**HENDERSON COUNTY
TECHINICAL REVIEW COMMITTEE**

SUBJECT: Combined Master and Development Plan for Orchards at Owensby Road
Major Subdivision (2020 – M03)

Henderson County Planning Department Staff Report

Staff has reviewed the submitted revised Combined Master and Development Plan for the Orchards at Owensby Road Major Subdivision, taking into consideration the recommendations of the *Henderson County Comprehensive Plan* and reviewing the plan for conformance with Henderson County Land Development Code. Staff offers the following comments:

MASTER PLAN
C-200
 SCALE: 1"=100'

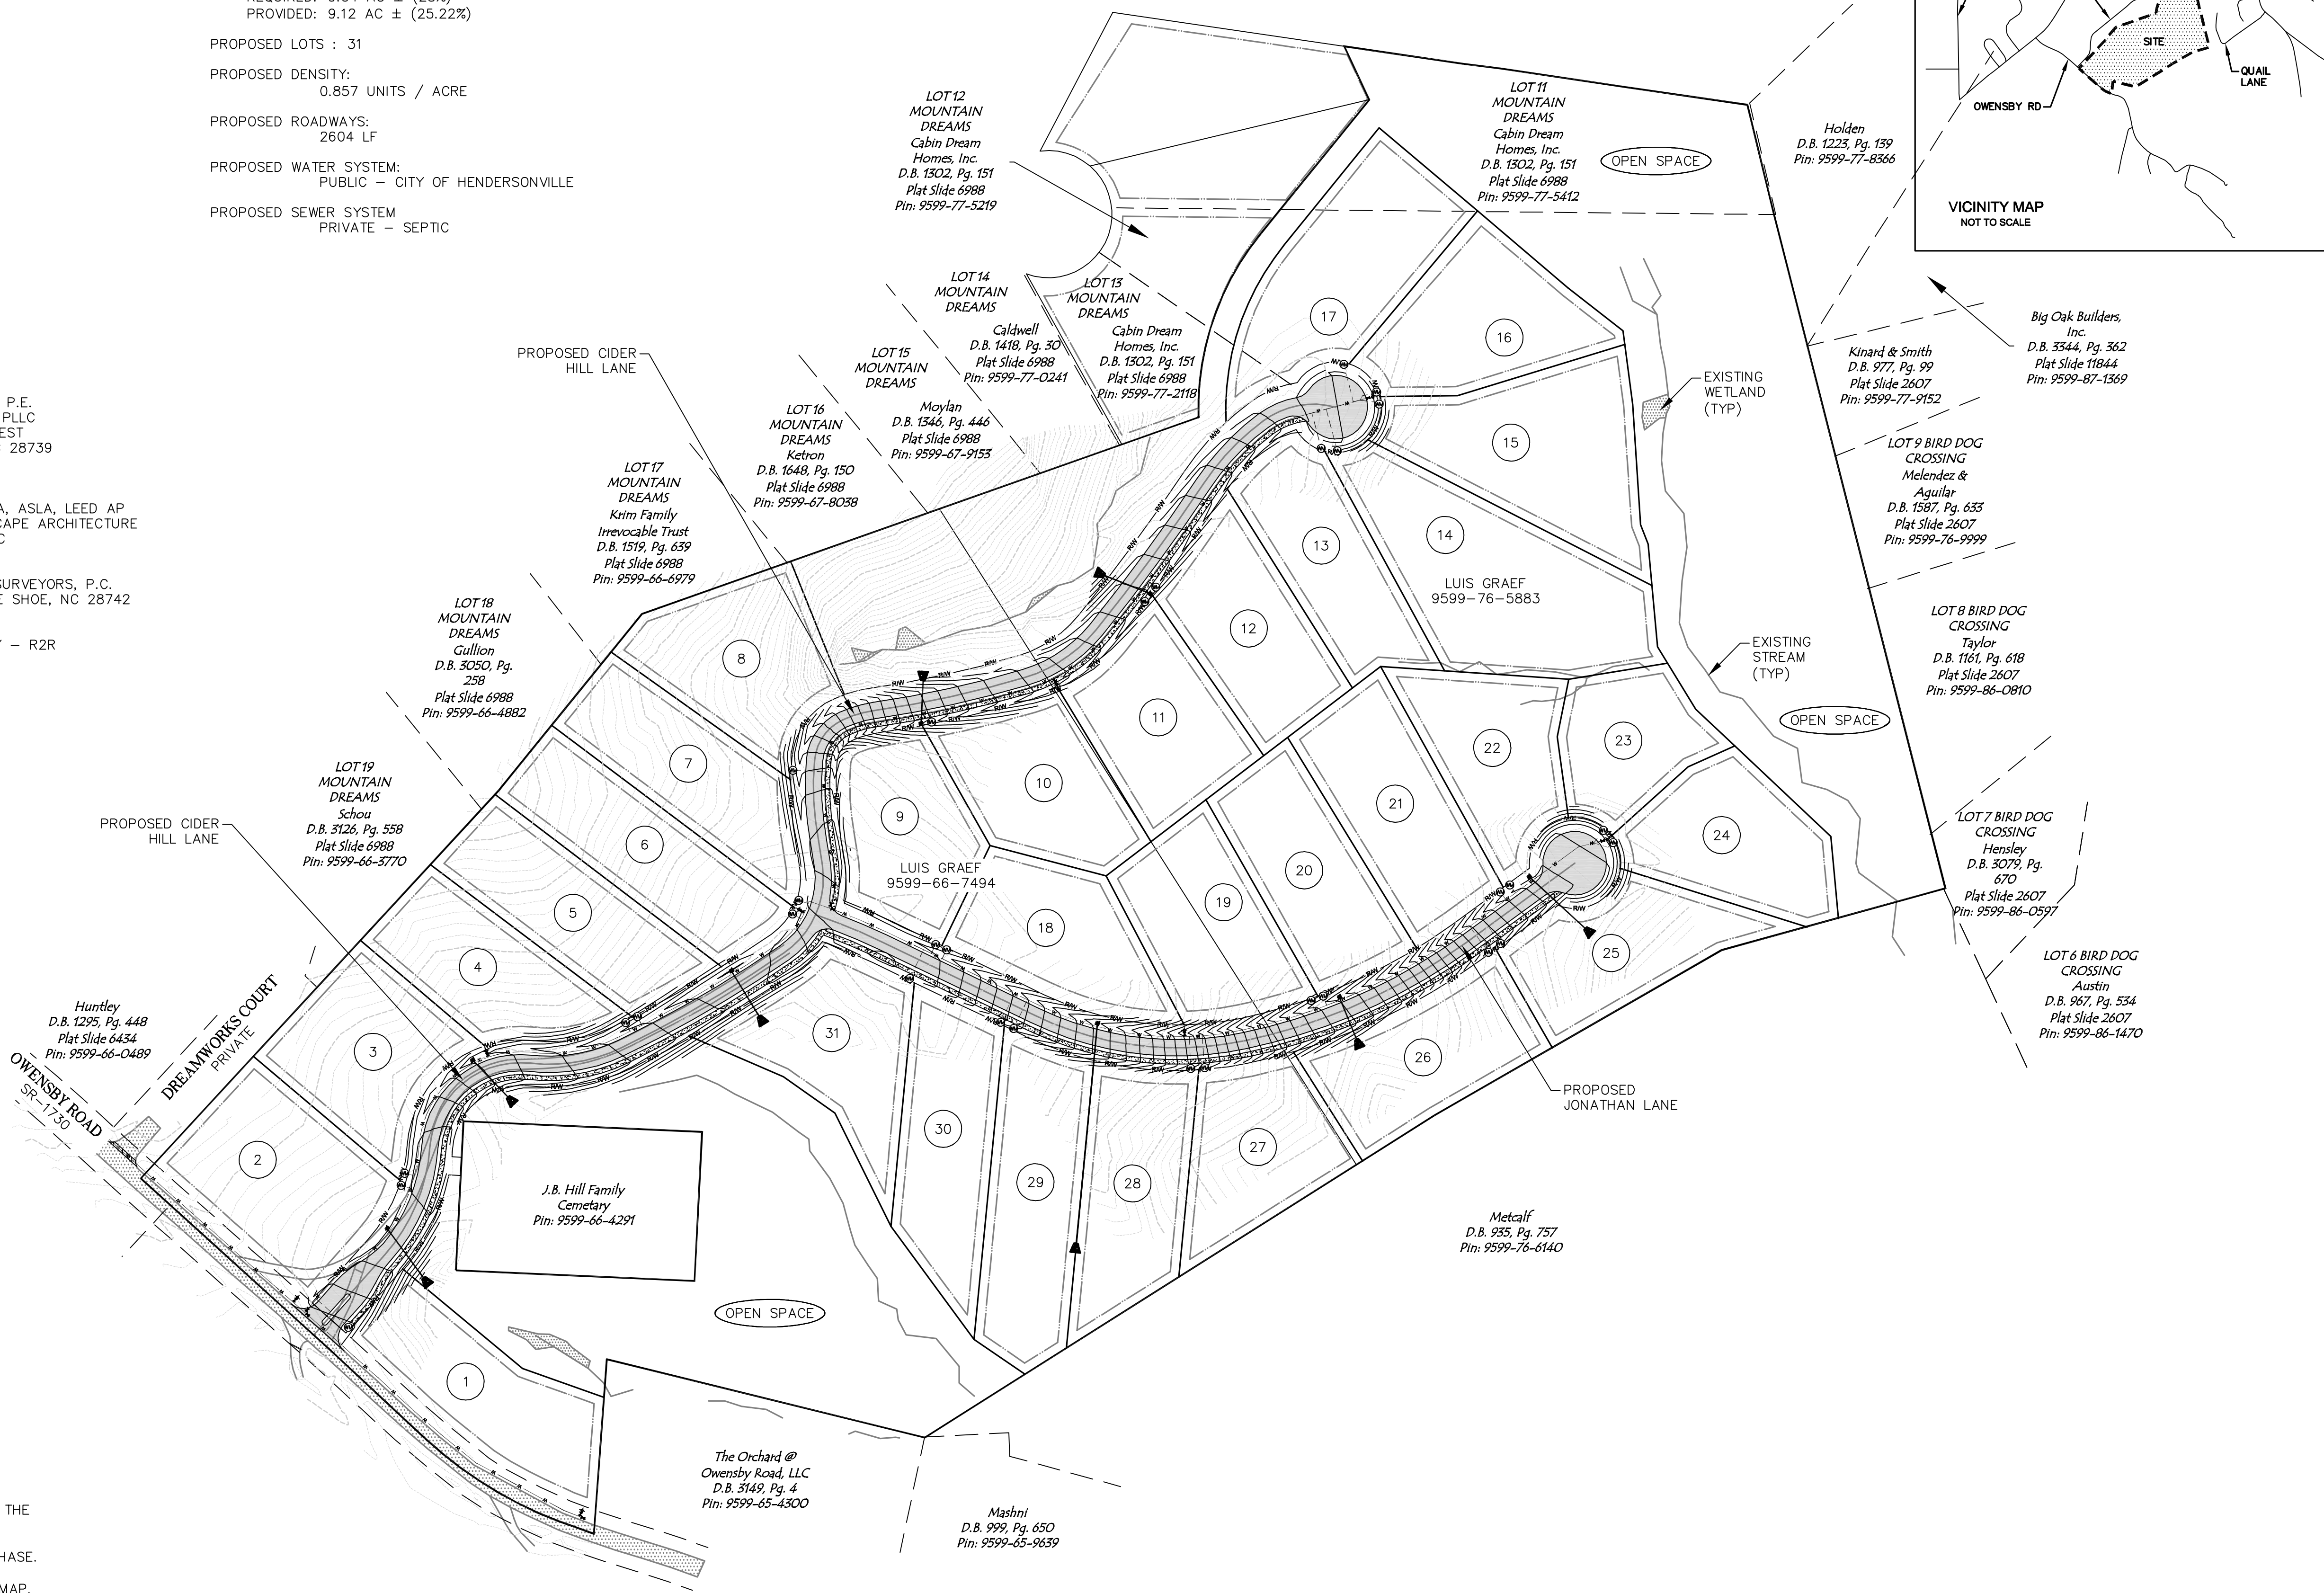
5. Perennial and Intermittent Surface Water Buffers: The project site is partially encumbered by multiple perennial and intermittent streams. Section §42-251 of the LDC regulates construction and permitting within the surface water buffer.

- a. Surface water buffers shall apply to all *built-upon area* and be at a minimum of 30 feet landward of all perennial and intermittent surface waters or 100 feet landward of any perennial surface waters located within a water supply watershed when using the *high-density option*

9. **Perennial and Intermittent Surface Water Buffer.** All built-upon area shall be a minimum of 30 feet landward of all perennial and intermittent surface water, as defined in LDC §42-251.

**SLOPE
MAP**

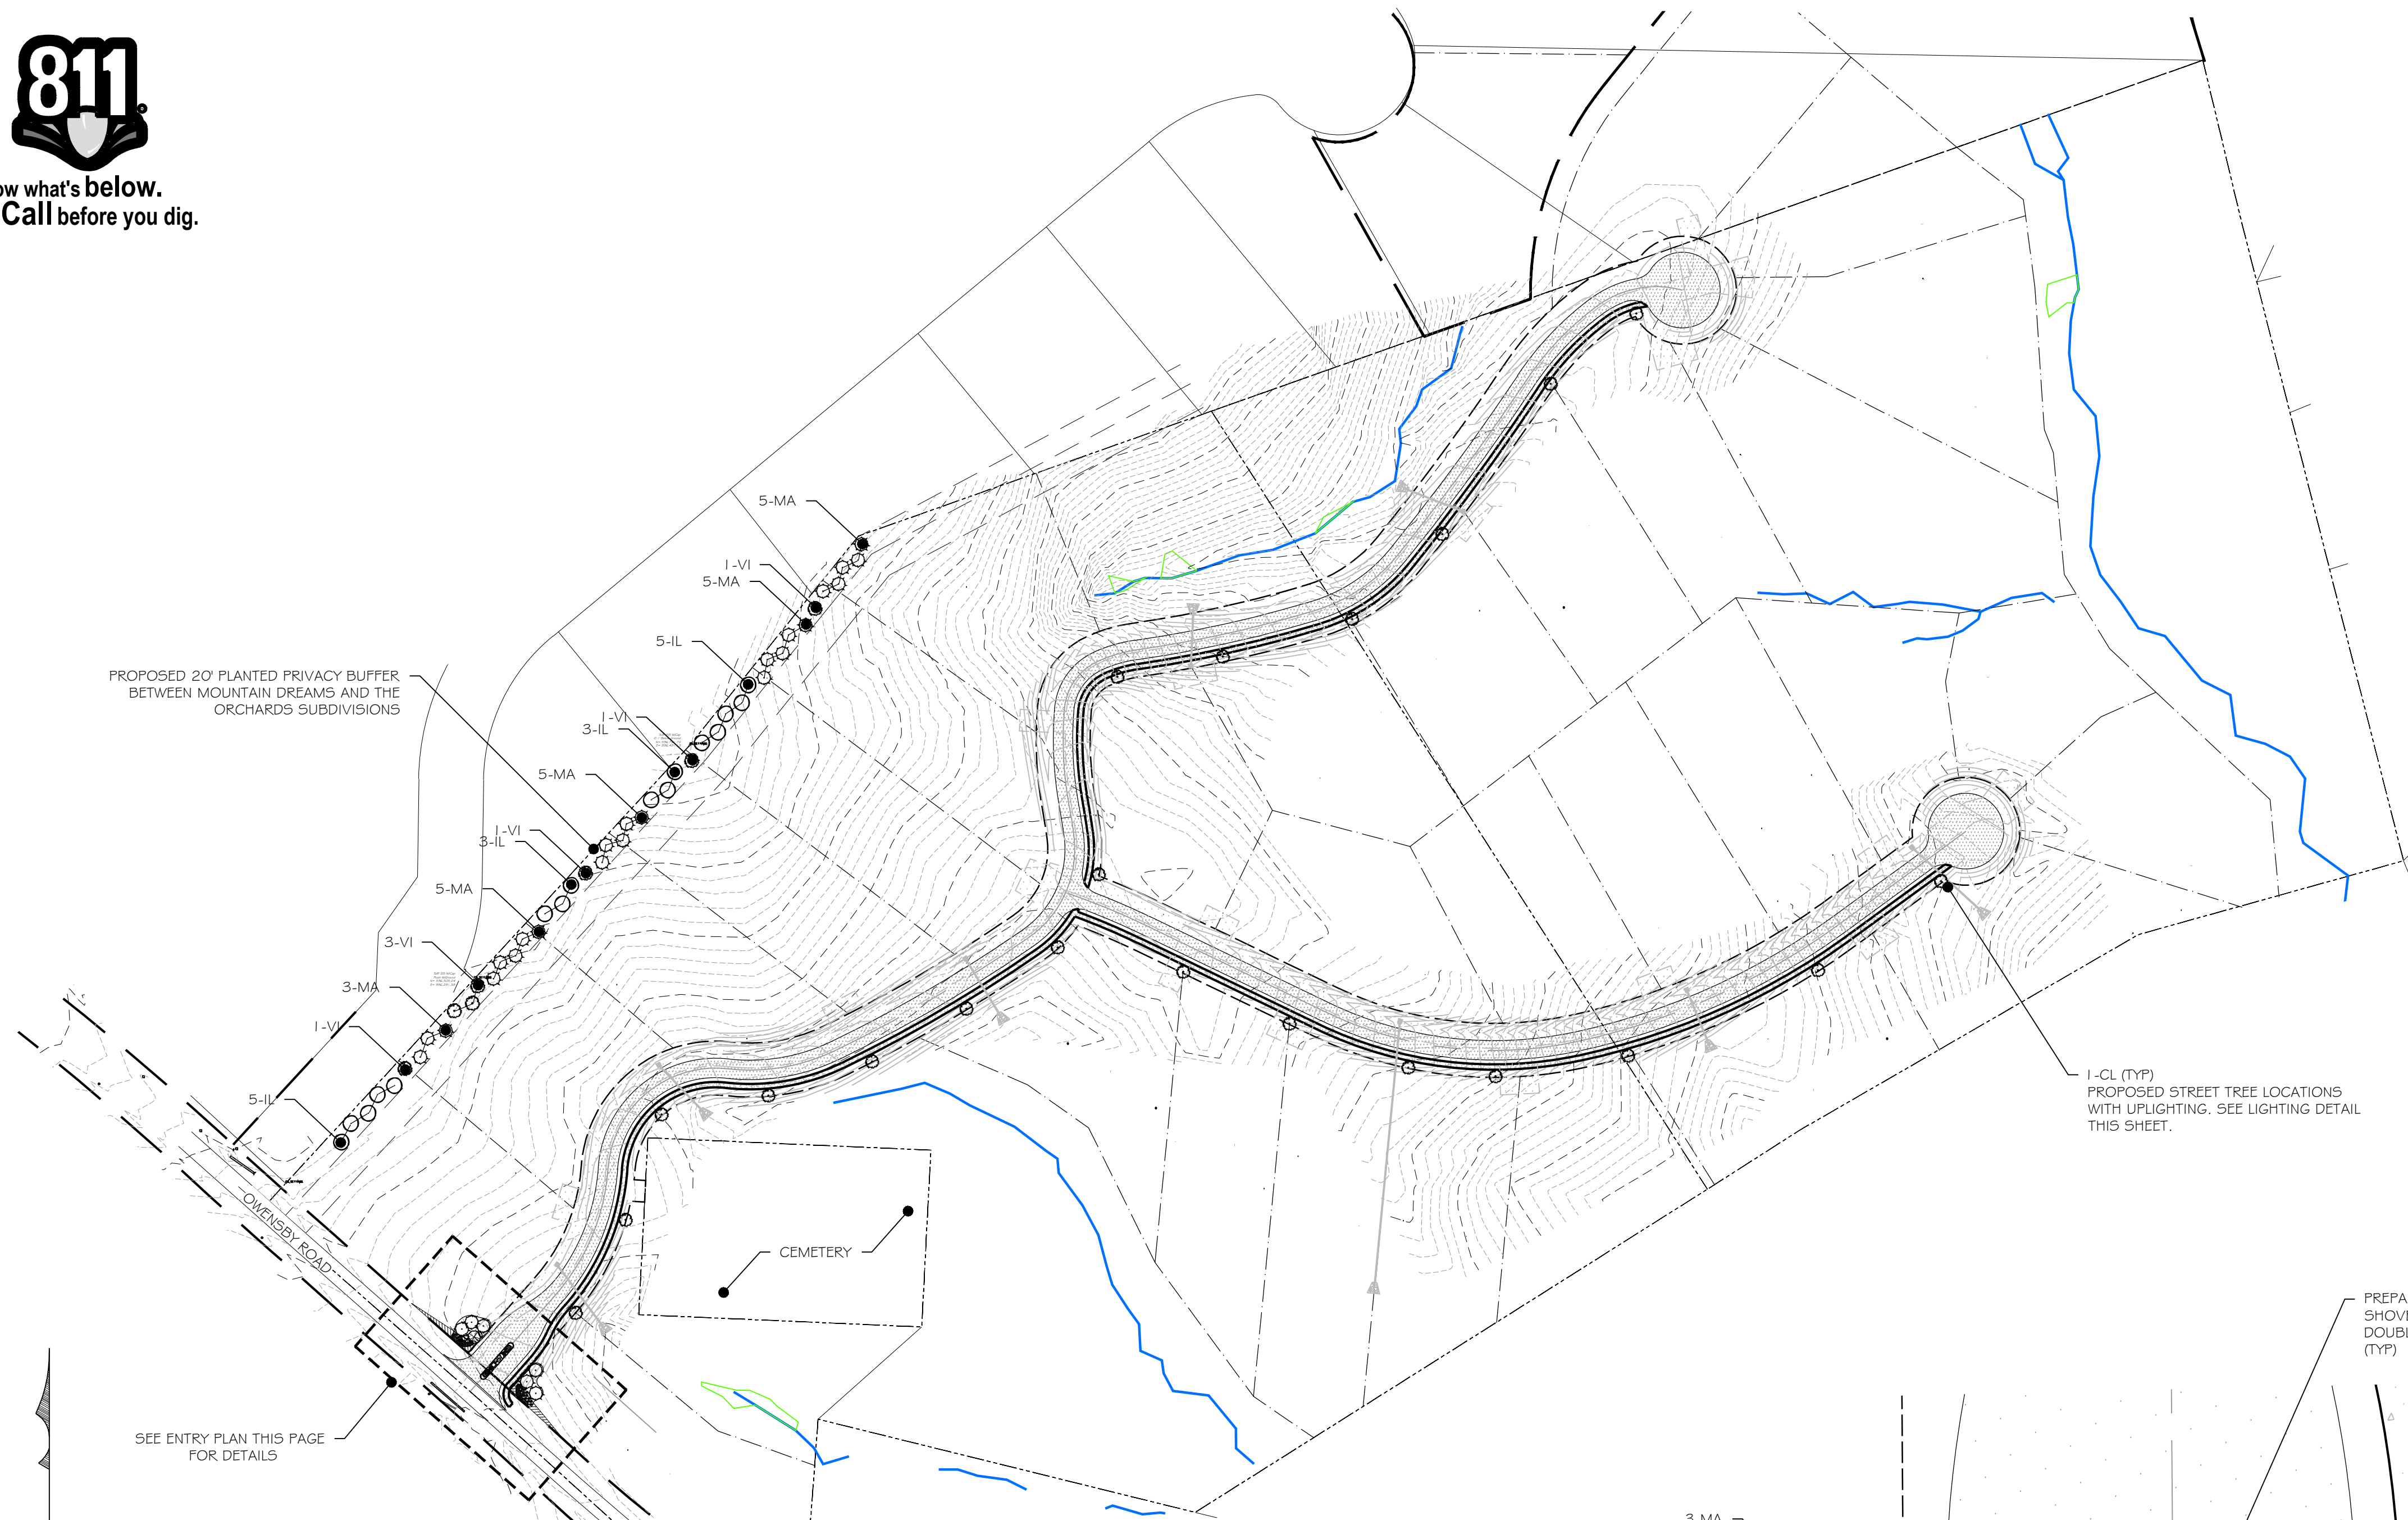
When reviewing the Combined Master and Development Plan it is important to consider that, due to severe topographic conditions, inadequate road access, distance from services, unique natural areas, soils that do not easily support soil drainage systems and/or the proximity to existing and incompatible land uses/zoning, all land may not be suitable to be subdivided for the purpose of dense development (LDC §42-75).
